ADDENDUM No. 1

Bid No. 21-22/37 – Building D-510 Janitorial Services

Revised Maps – 2nd Floor Plan

HFC BUILDING – 2ND FLOOR PLAN
SCALE: 1/8"=1'-0"

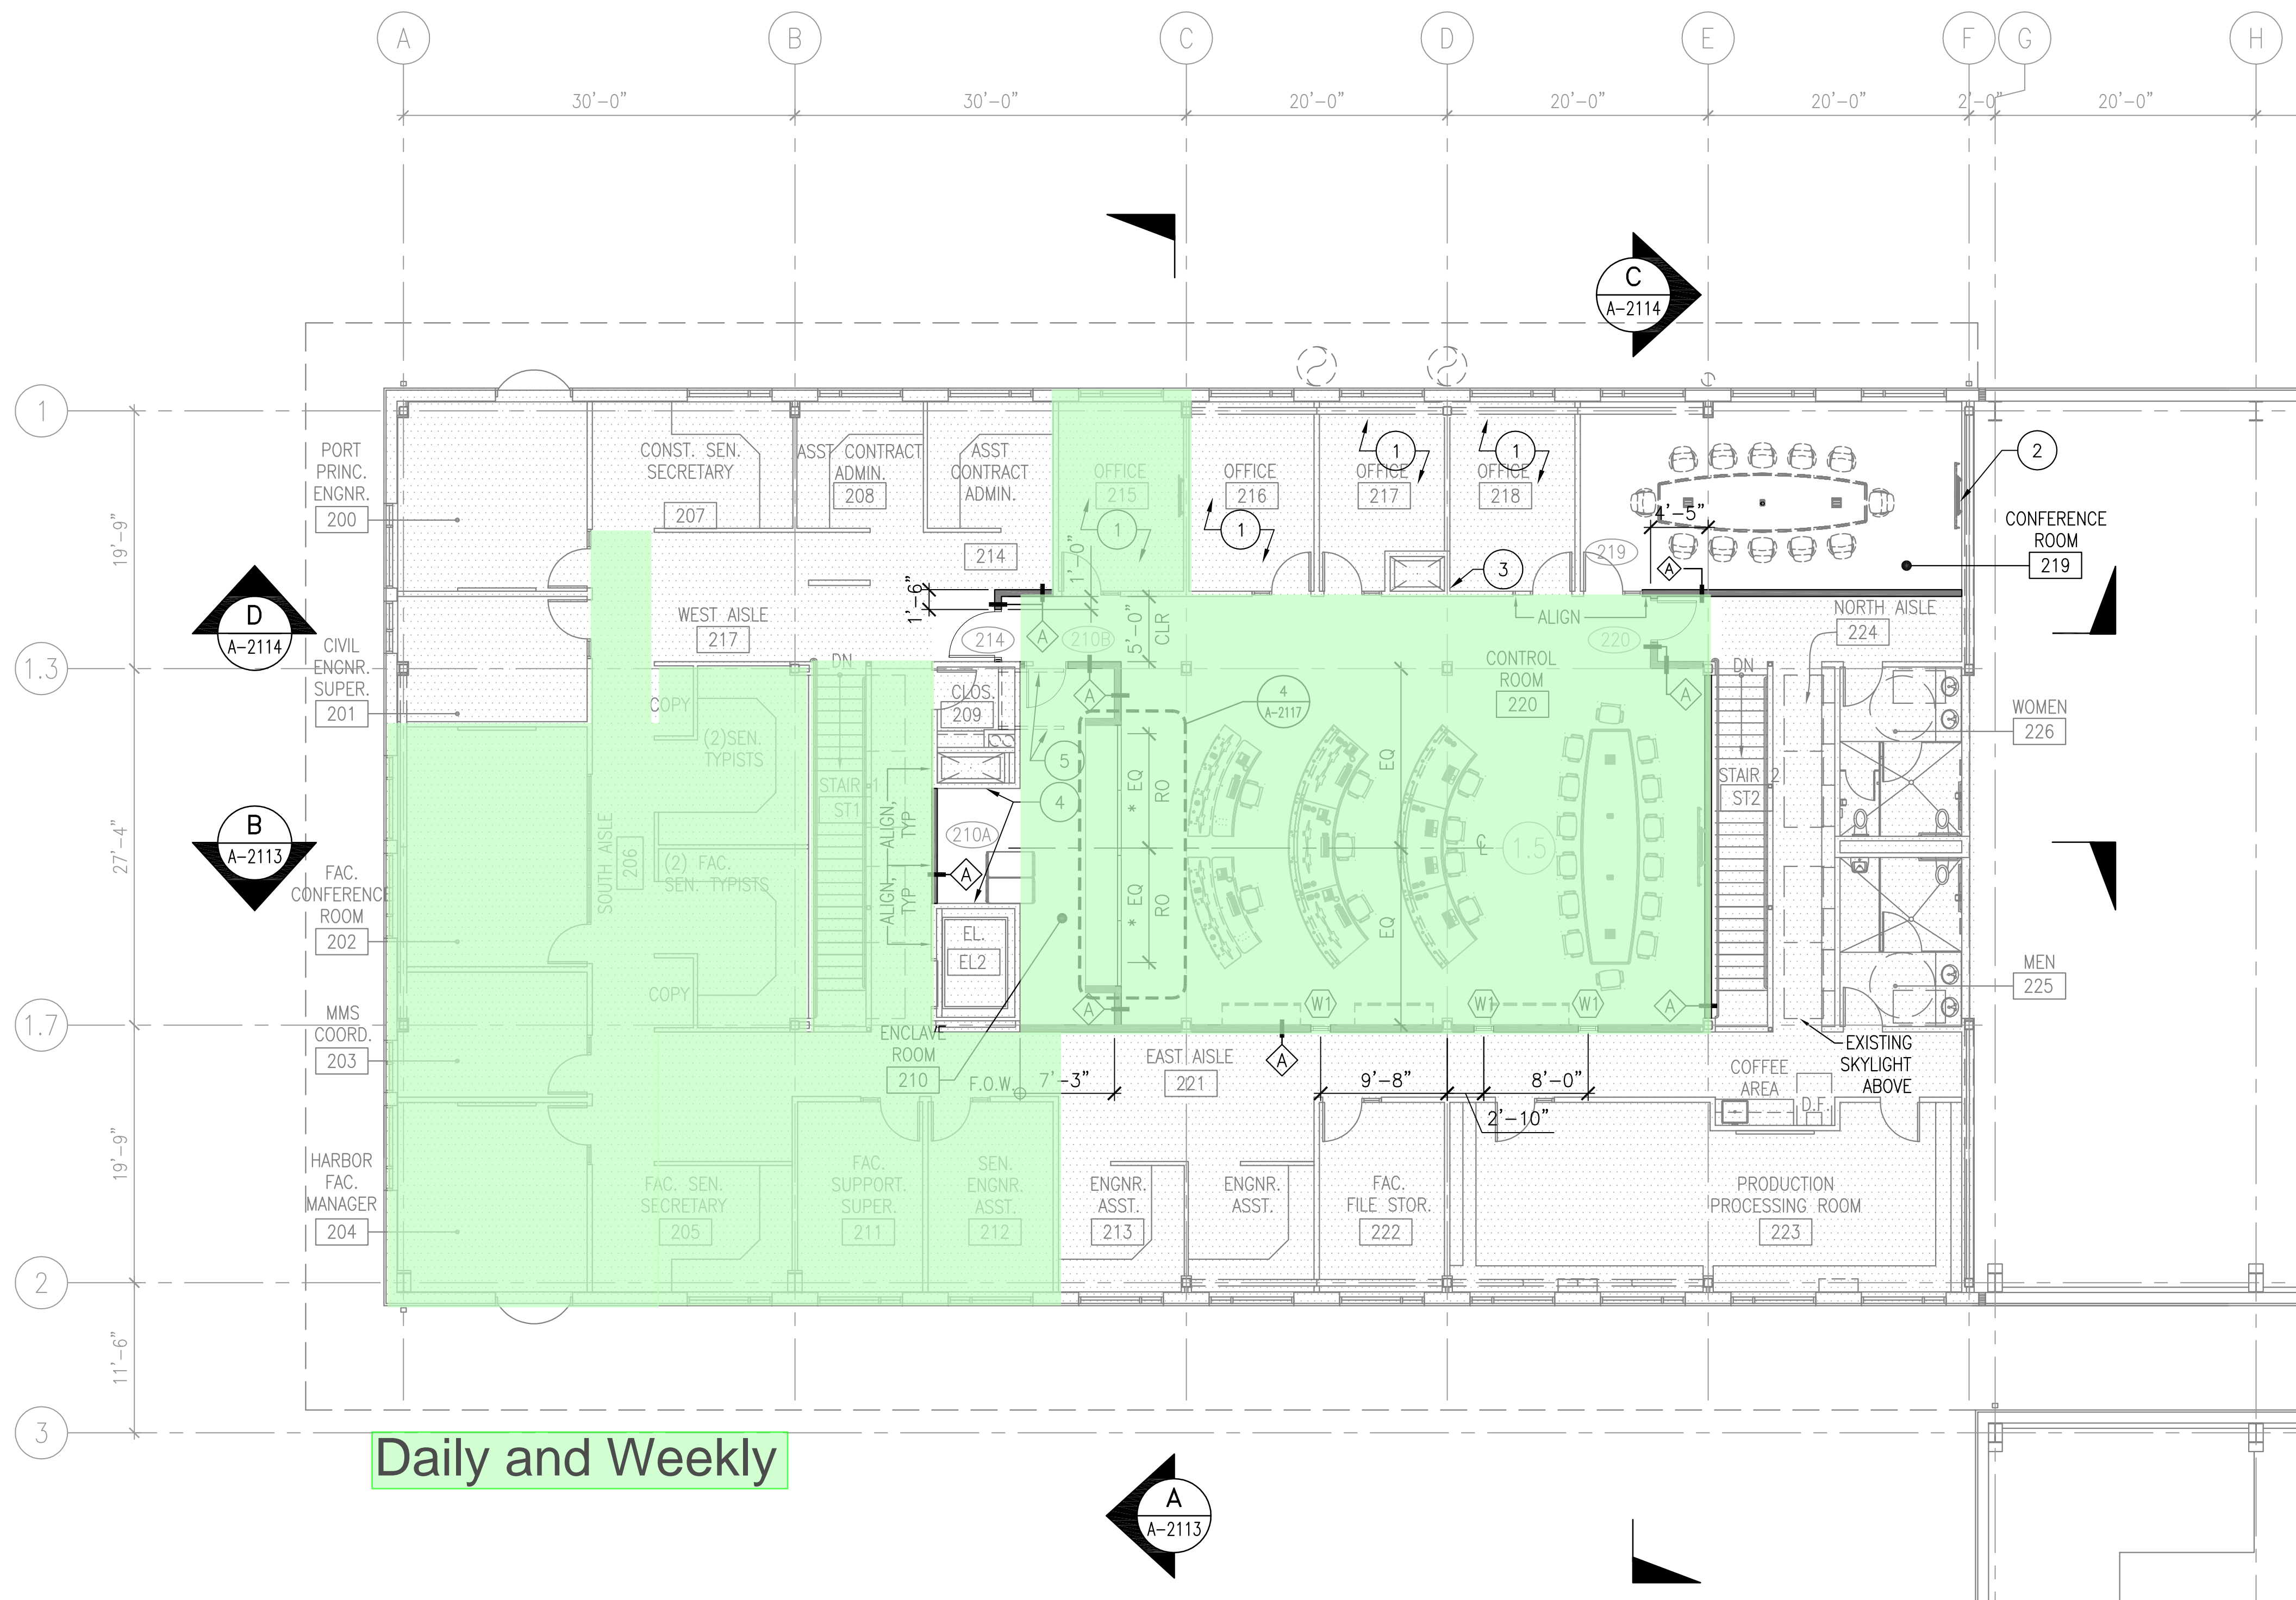
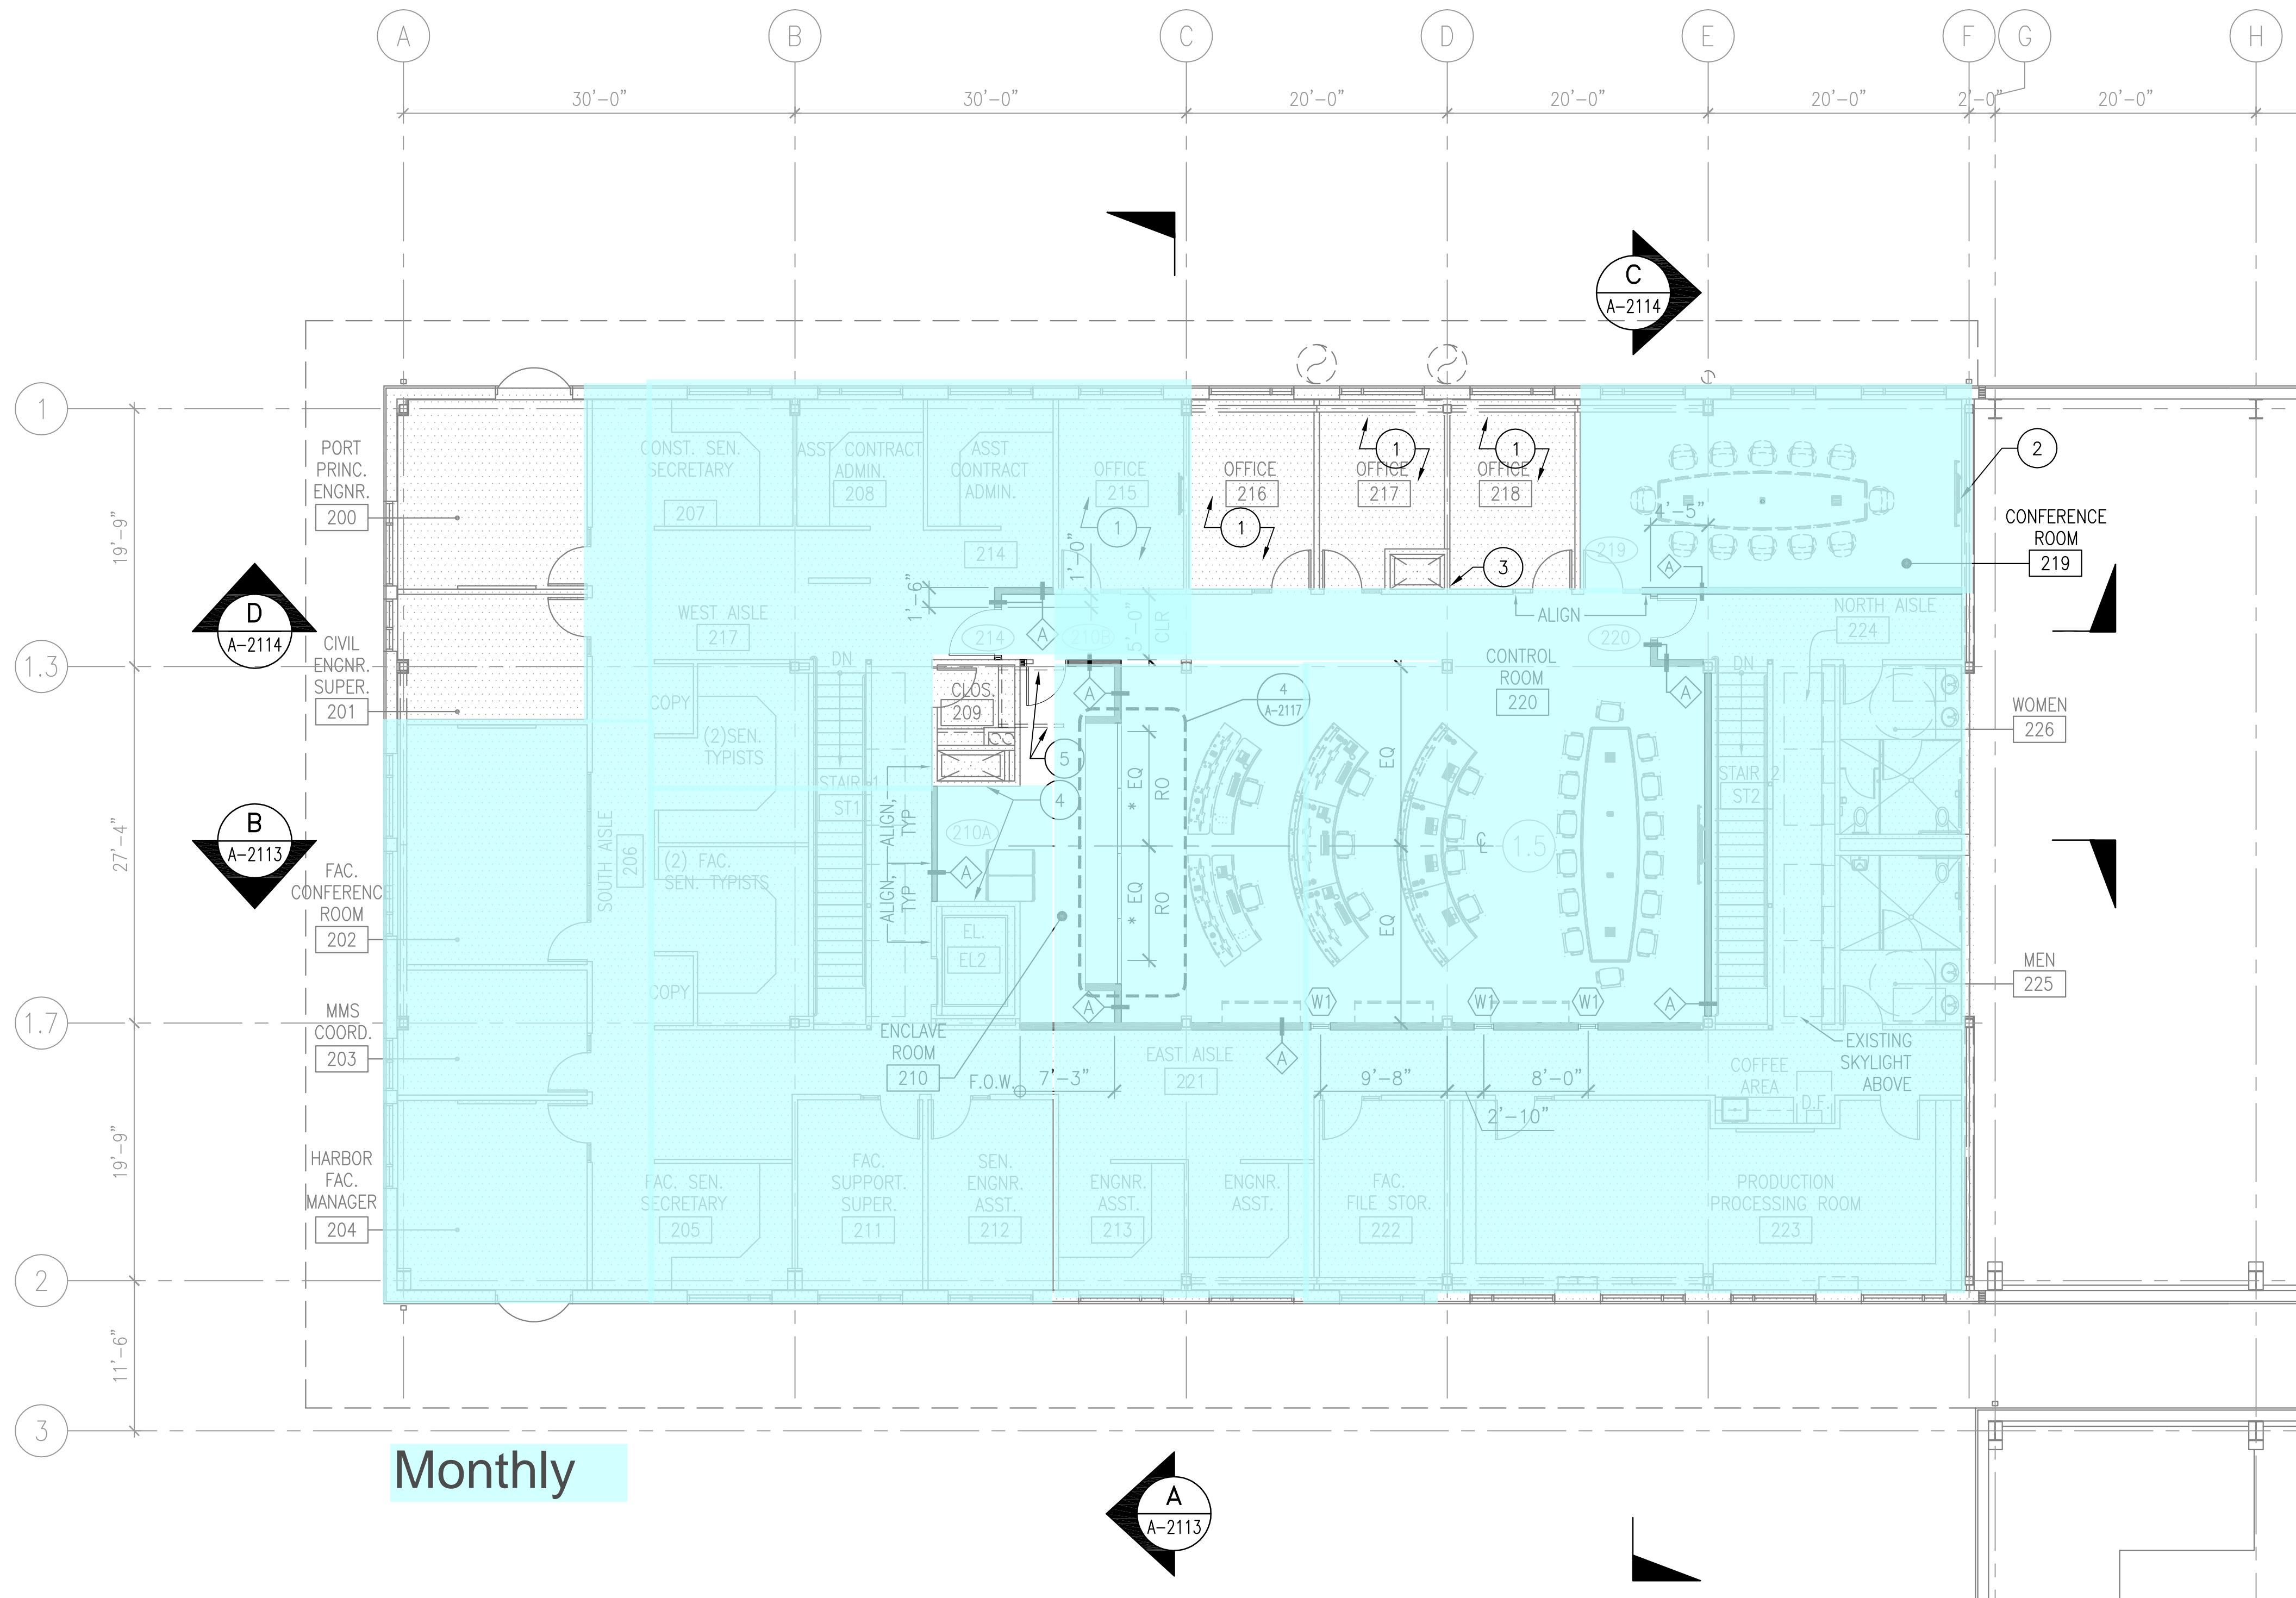
1. Port of Oakland has updated 2nd Floor maps titled “ADMINISTRATION SECOND FLOOR PLAN – AREA 1” with the revised “HFC BUILDING – 2ND FLOOR PLAN” maps for Daily and Weekly; Monthly, and Quarterly, see Attachment 1 of this Addendum for revised floor maps.
